Planning Commission Staff Report

February 27, 2013
Item 6.d.

SUBJECT:	**Appeal of P12-1791**
APPLICANT/ APPELLANT:	Rajitha Sumanasekera, Little Flowers Montessori
PROPERTY OWNER:	Sim & Yoon LLC
PURPOSE:	Appeal of the Zoning Administrator's denial for Sign Design Review to retain a non-approved but already installed non-illuminated wall-mounted sign.
LOCATION:	3550 Bernal Avenue, Suites 115, 120, and 125
GENERAL PLAN:	Retail/Highway/Service Commercial; Business and Professional Offices.
ZONING:	PUD-C-N (Planned Unit Development – Commercial - Neighborhood) District.
EXHIBITS:	A. Draft Conditions of Approval B. Site and Wall Sign Plans dated "Received November 27, 2012" C. Zoning Administrator's Denial Letter dated "December 18, 2012" D. Letter of Appeal dated "Received January 2, 2013" E. Vintage Hills Shopping Center Comprehensive Sign Program and Amendments F. Location and Noticing Maps

Figure 2: Approved Tenant Sign

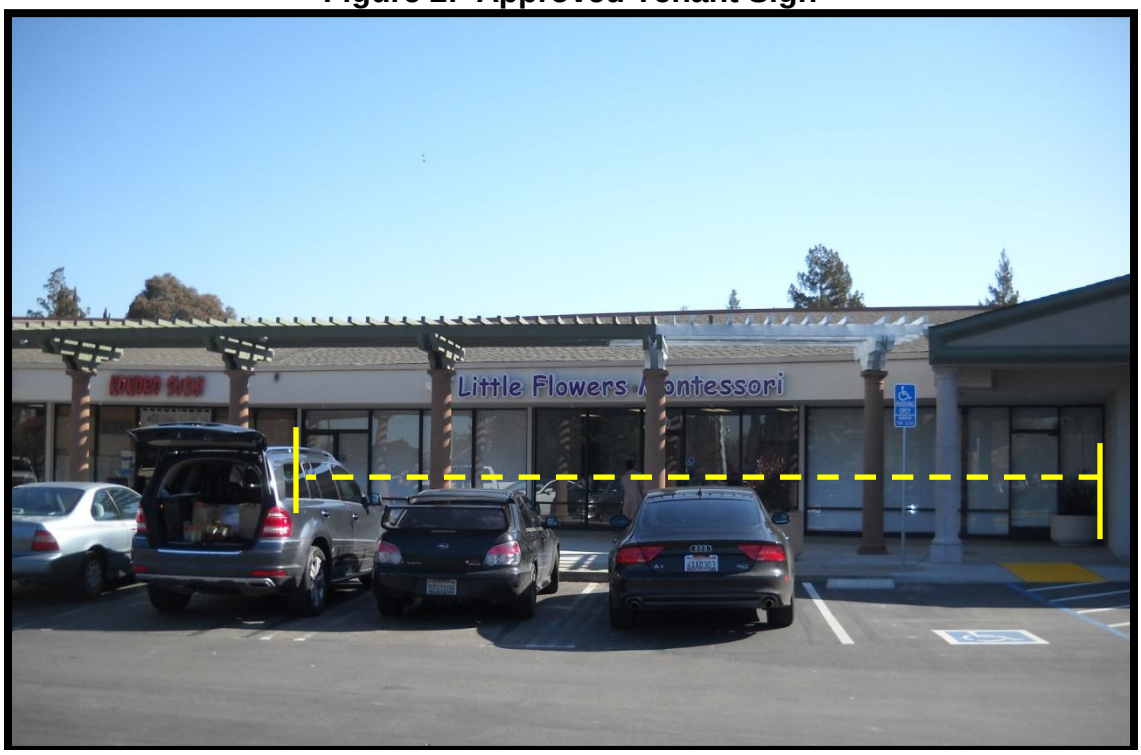
Little Flowers Montessori received approval to install one 18-inch tall, 22-foot 5-inch long, internally illuminated sign above the child care center. Please refer to Figure 2 below for the photograph of the approved sign. The applicant is requesting to retain the 2-foot tall, 9-foot, 5-inch long, double stacked, non-illuminated, wall-mounted sign located adjacent to Little Flower Montessori's main tenant entrance. Although the applicant shares a common wall with the adjacent use, Anytime Fitness, the portion of the wall where the sign is located is on a portion of Anytime Fitness's wall that is not a shared wall. Please refer to Figure 3 on page 4 for the picture of the wall-mounted sign and its location.

Figure 3: Tenant Walls and Sign Location

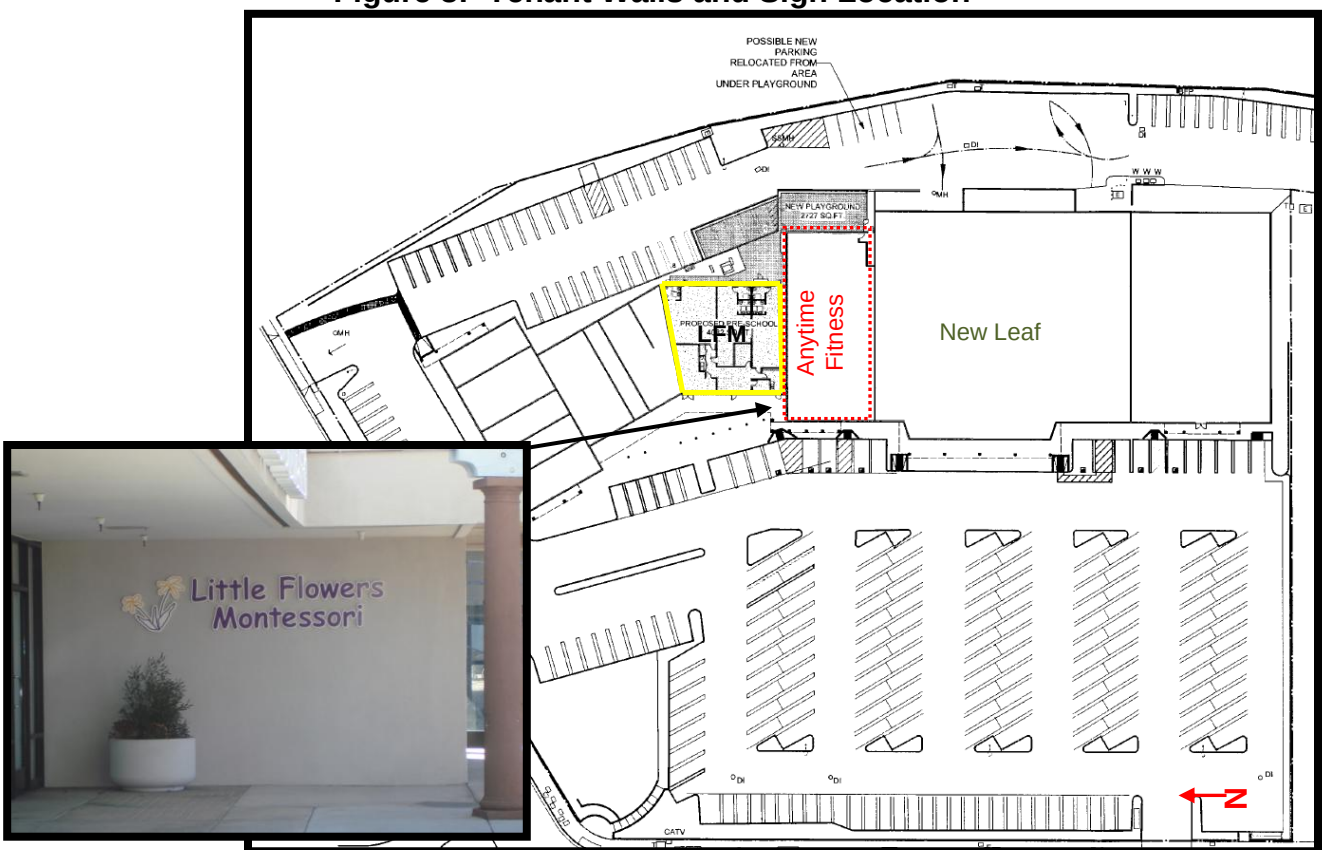
Staff believes that it is not appropriate to have the wall-mounted sign on the adjacent tenant's wall and that the existing fascia-mounted sign for Little Flowers Montessori provides adequate tenant identification for cars approaching the tenant space. If pedestrian-oriented signage is desired, staff believes there are better options, such as adding blade signs mounted below the soffit adjacent to the tenant entry or window signage, which would be reviewed as part of a comprehensive sign program modification applicable to all tenants in the shopping center rather than to a single tenant to ensure that the locations and design are appropriate.

The Planning Division has completed its Sign Design Review procedure for your proposal to **retain the existing non-illuminated, wall-mounted sign located on the north wall of the existing building located at 3550 Bernal Avenue, Suite 110.** Based on the information submitted, the Zoning Administrator has determined that: (1) the sign is not located on a wall/tenant space associated with Little Flowers Montessori, which is located in Suites 115, 120, and 125; (2) Little Flowers Montessori already has approved tenant signage above their associated tenant spaces; and (3) the wall sign is not consistent with the comprehensive sign program for Vintage Hills Shopping Center and, therefore, the Sign Design Review application is not approved.

Consider point 1), As the photograph below illustrates, the sign on the side wall is facing the Little Flowers Montessori (LFM) tenant spaces. The next door tenant has premium signage at the front of the building. The side wall sign does not impact the adjacent/next door tenant space. The landlord has also approved the side sign. Other tenants and the landlord have also indicated that the sign makes that wall nicer than it was previously.

Staff recommends that the Planning Commission deny the appeal of P12-1791, thereby upholding the Zoning Administrator's denial of the wall-mounted sign.

The wall sign shall be removed within 14 days of the effective action date.

EXHIBIT B

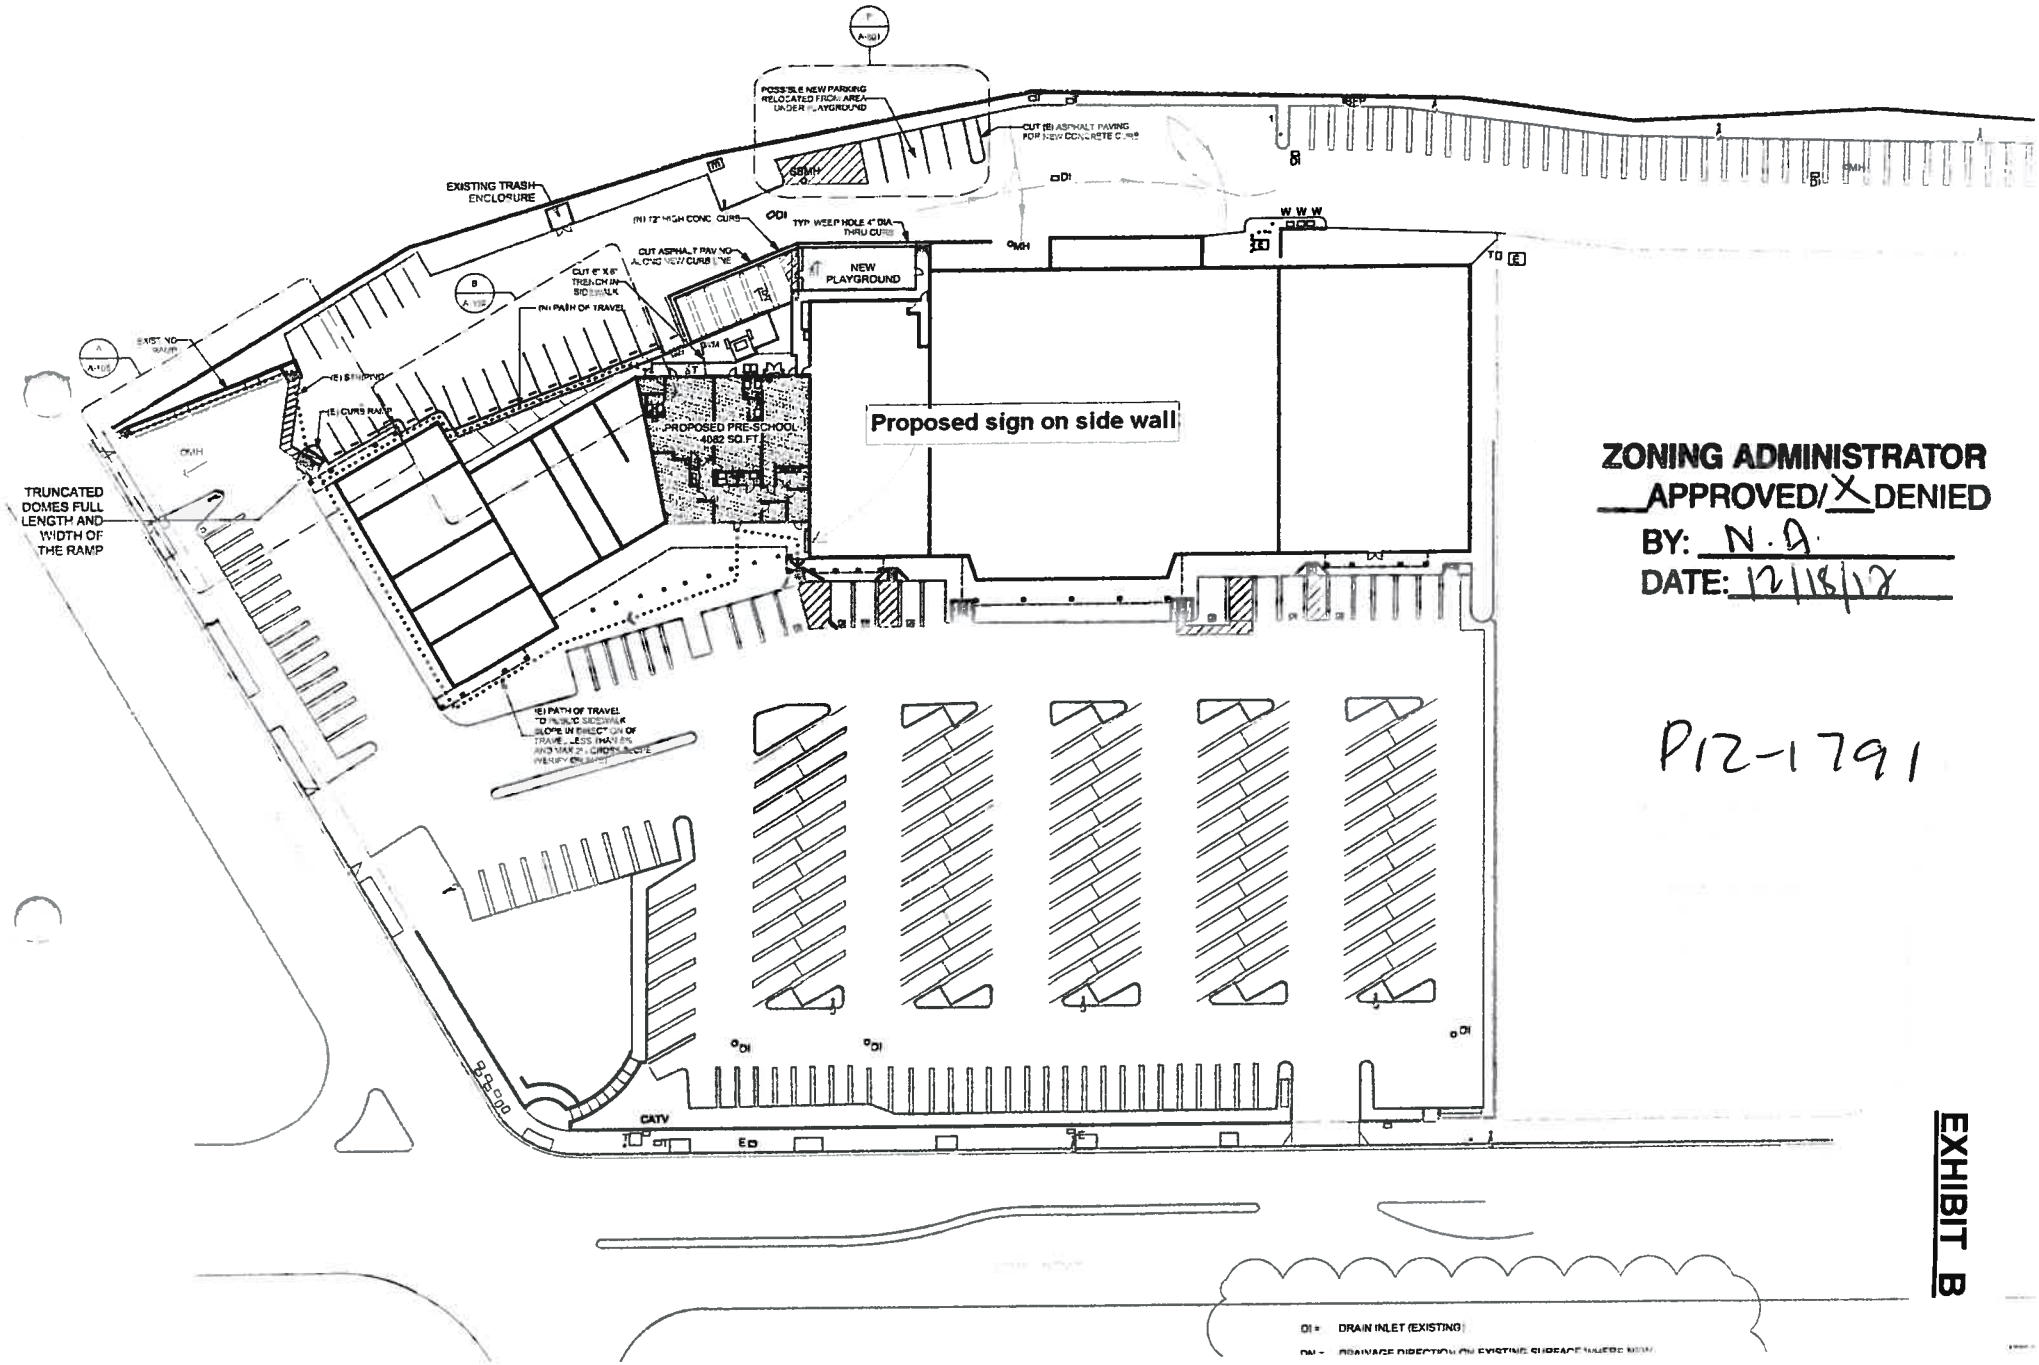
ZONING ADMINISTRATOR
___APPROVED/X DENIED
BY: N.A.
DATE: 12/18/12

1. The non-illuminated, wall-mounted sign shall conform substantially to site plan and elevation drawing, Exhibit B, marked "Received January 2, 2013," on file at the Planning Division. Minor changes to the sign may be approved by the Director of Community Development if found to be in substantial conformance with this approval.
